Product Name: DePuy ReClaim® Reamer Extension

FSCA-identifier: DVA-107508-HHE

Type of Action: Field Safety Notice

Date: Oct 2014

Figure 1: Affected RECLAIM Distal Reamer Extension (2975-00-500)

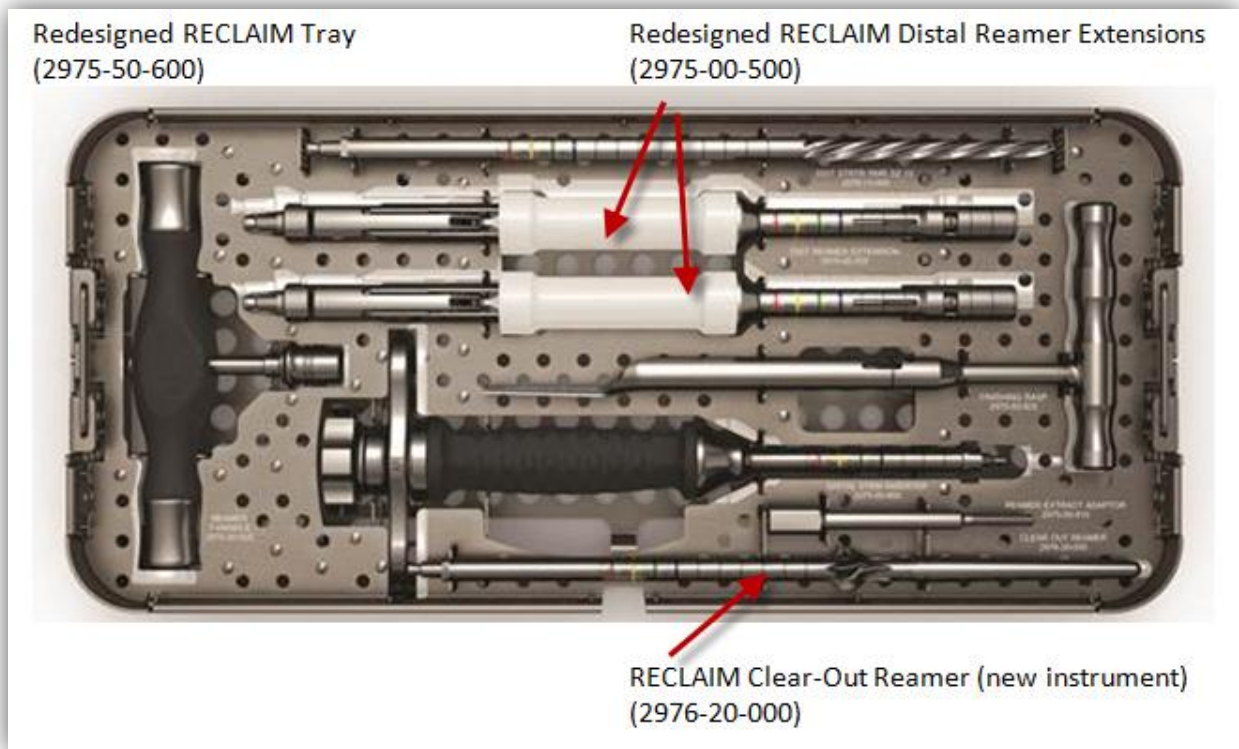
In March 2013, DePuy Orthopaedics, Inc. issued a voluntary device correction for the RECLAIM® Distal Reamer Extension (2975-00-500) due to the potential for one or both of the tabs on the original design to break off and potentially be left in the patient. The RECLAIM® Distal Reamer Extension has been redesigned, and the company is formally swapping out the affected instruments.

Prior to the instrument's redesign, DePuy Orthopaedics, Inc. identified the potential for the RECLAIM Distal Reamer Extension tabs to break off. DePuy has received 9 complaints reporting tab breakage since 2011. None of the complaints have indicated fragments were left in patients. Since the device correction, there have been 37 additional complaints regarding the tabs breaking. Also,

Figure 2: Redesign RECLAIM® Instrument Tray (2975-50-600) – Note: The swap-out set will contain: 1 #2975-50-600 (empty), 2 #2975-00-500 (redesign distal reamer extensions), and 1 #2976-20-000 (clear out reamer)

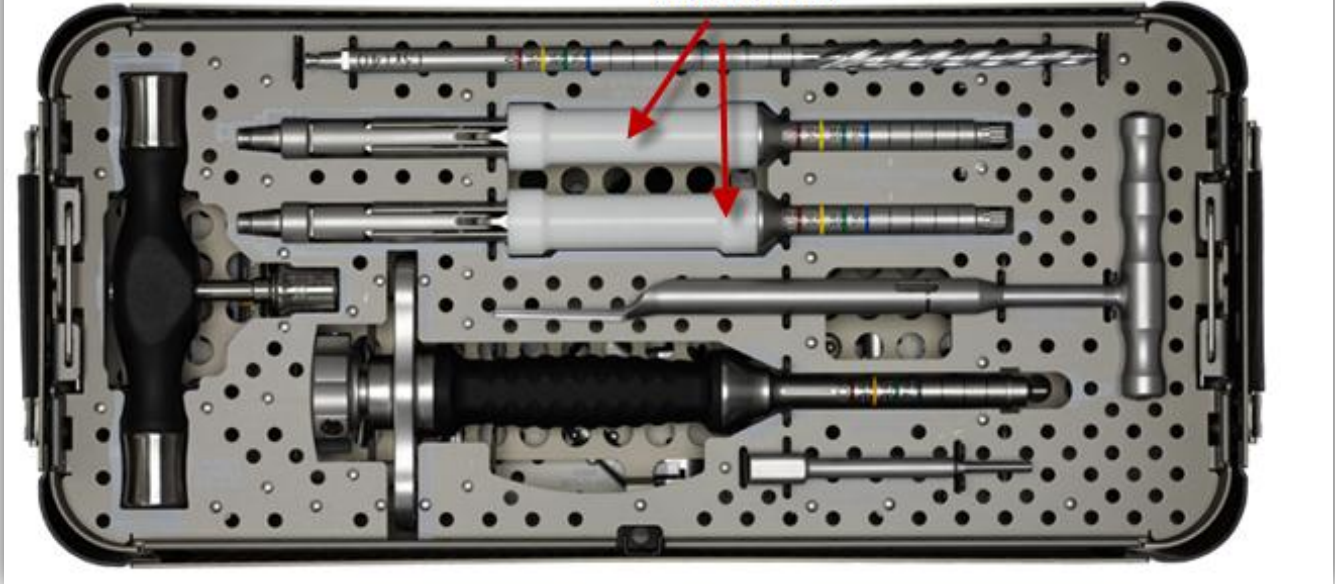
The redesigned instruments include a RECLAIM Clear-Out Reamer (2976-20-000) and an updated RECLAIM Instrument Tray (2975-50-600), which will be included as part of the swap-out set.

The swap-out set will consist of (see Figure 2):

Figure 4: Visual Comparison Between the Redesigned Instrument and Tray and the Affected Instrument and Tray.
NOTE: The part number is the same for the Affected & the Redesigned Distal Reamer Extensions (2975-00-500)

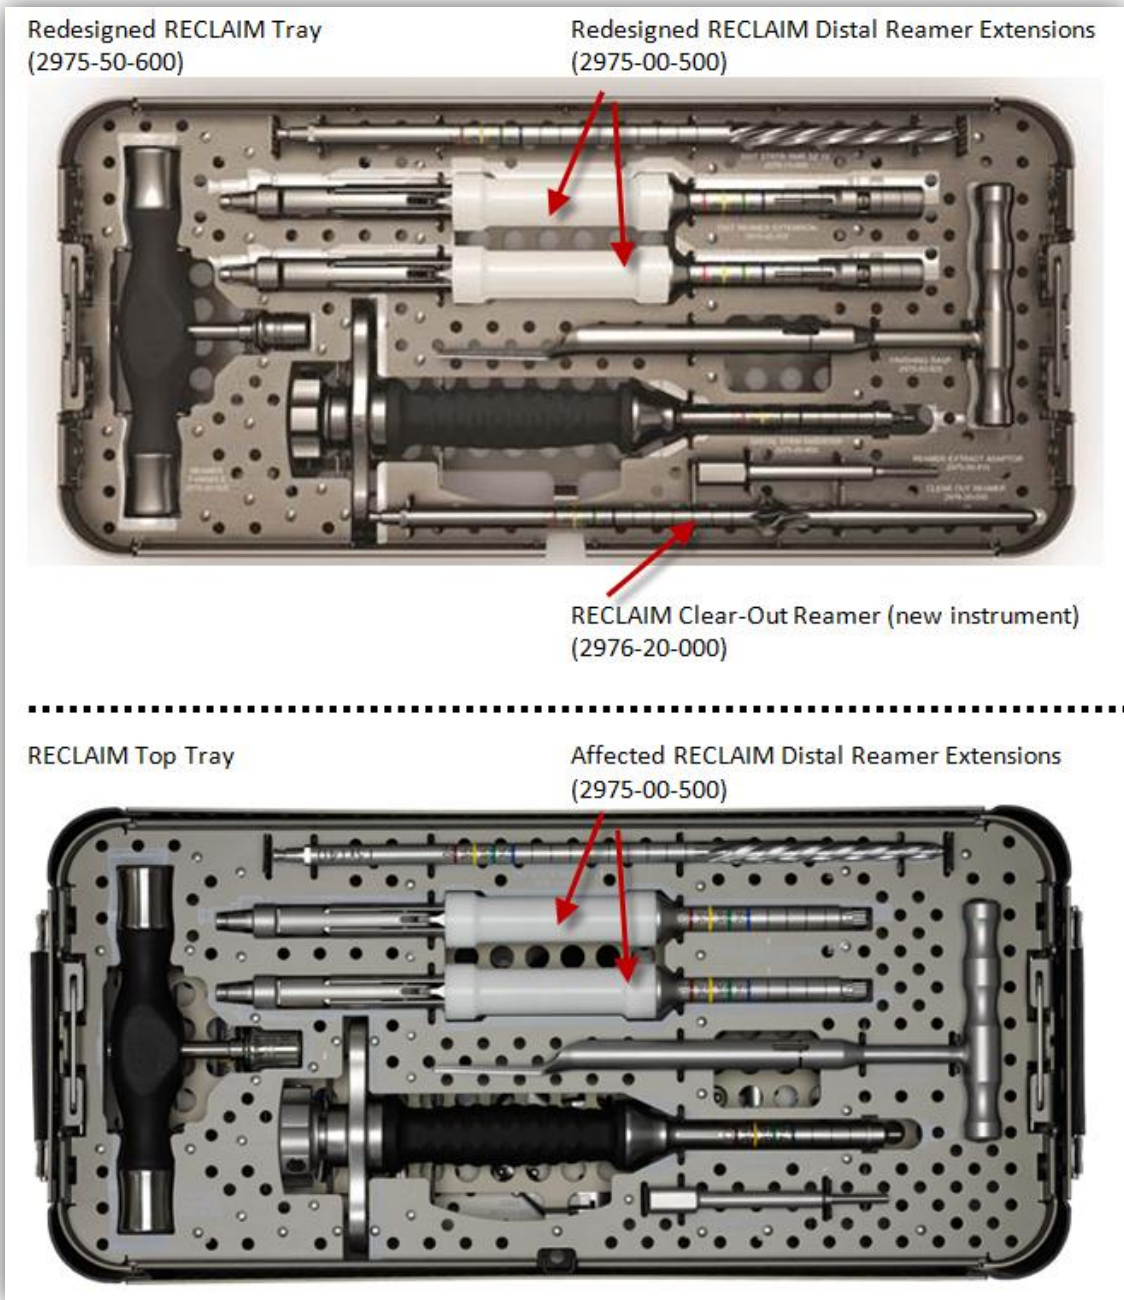
The figure below highlights the redesigned swap-out distal reamer extension instruments, tray, and clear-out reamer compared with the affected instruments and tray:

Figure 5: Visual Comparison Between the Affected RECLAIM Distal Reamer Extension and the Redesigned RECLAIM Distal Reamer Extension
– NOTE: The part number is the same for the Affected & the Redesigned Distal Reamer Extensions (2975-00-500)

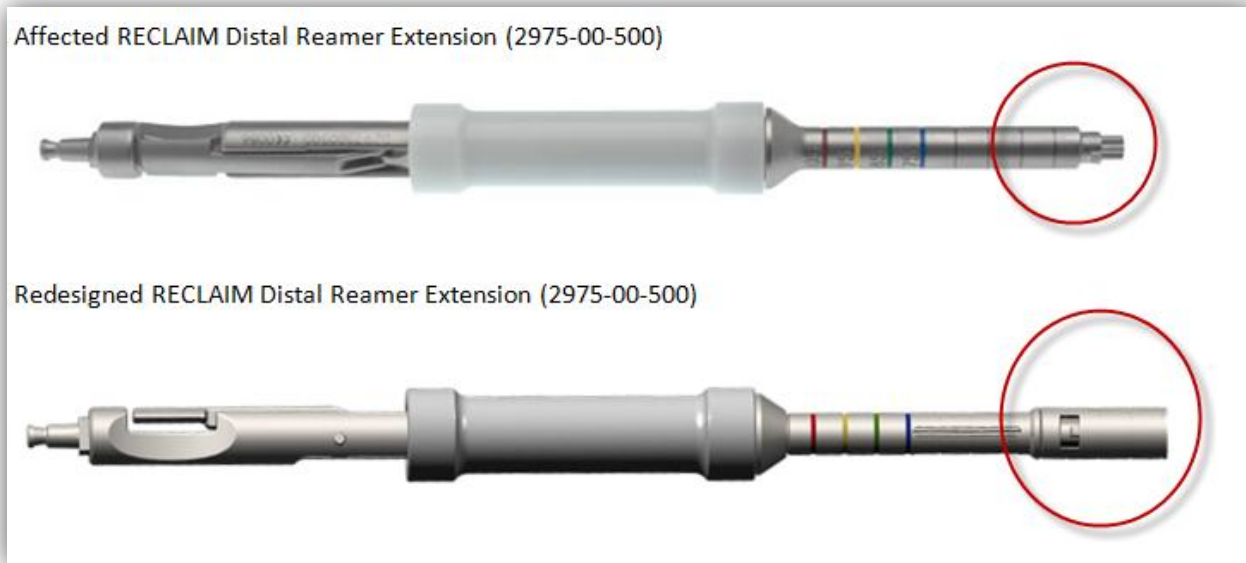
The image below compares the affected distal reamer extension with the redesigned distal reamer extension:
